W3F1-2010-0089

Subject: Response to Request for Additional Information Associated with
Technical Specification Table 3.4-1 Isolation Valve Addition
Waterford Steam Electric Station Unit 3
Docket No. 50-382
License No. NPF-38

Response to Request for Additional Information

**LPL-EQA-35.1 Qualification Test Summary / Similarity Analysis / Temperature
Service**

Figure A: Heat Rise Test Thermocouple Position and Final Temperatures

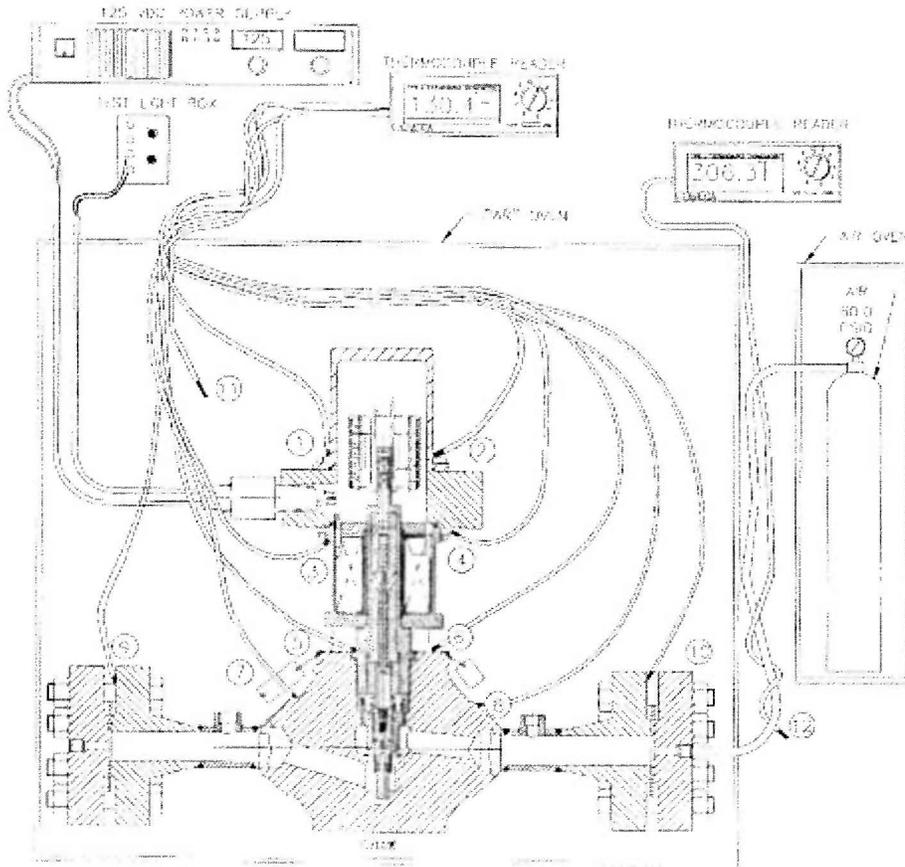
The service temperature of the elastomers, O-rings being the life limiting component, (Dwg. 214167301 items 27 and 43) is calculated based on thermocouple temperatures that were recorded during the heat rise test and shown below in Figure "A". The service temperatures for the O-rings are much lower based on the elastomer location within the valve and the thermal conduction paths from the coil. The locations are depicted below as thermocouple locations 1-4. A conservative service temperature chosen for the O-rings is 240°F while the valve is open and 180°F while the valve is closed.
